**Re: Comment Letter for Proposed Redevelopment of 6950 SE Maker Street  
Permit No. 2207-019**

On behalf of our client, Dan Grove, we submit these comments on the permit application for the proposed demolition and rebuild of the home located at 6950 SE Maker Street (the “Strand Property”) pending under Permit No. 2207-019 (the “Permit”). Mr. Grove owns the house immediately adjacent to the east of the Strand Property and is acutely familiar with the issues discussed in this letter. Mr. Grove respectfully requests notice and a copy of the permit decision once made by the City.

# **EXHIBIT A**

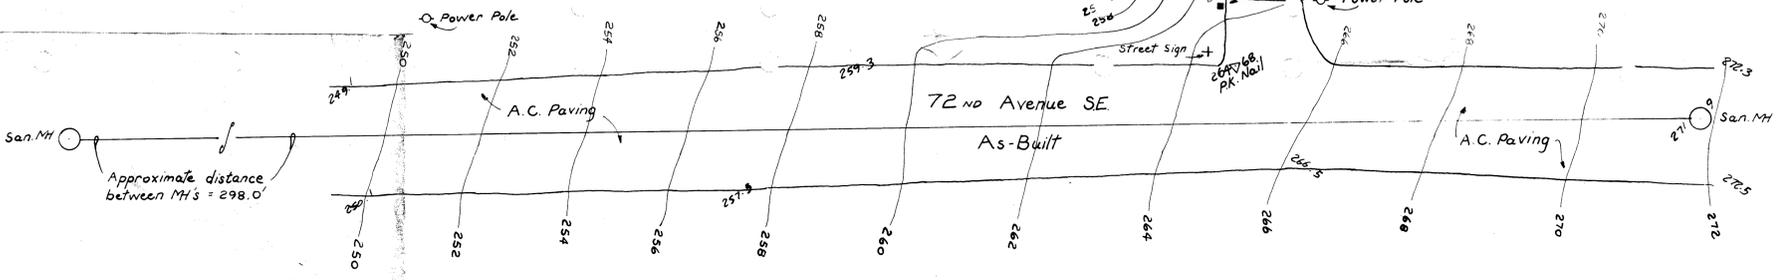
- Attached as **Exhibit A** is a survey of the property to the north of the Strand Property, located at 7145 SE 35th Street, dated May 1989 ("7145 Survey"). It includes the grade of the basement of what is now the Strand Property. This survey shows the basement floor elevation as 227.6' and includes the existing grade adjacent to the 6950 home as ranging from 227.7' to the east, to 233.9' to the west.
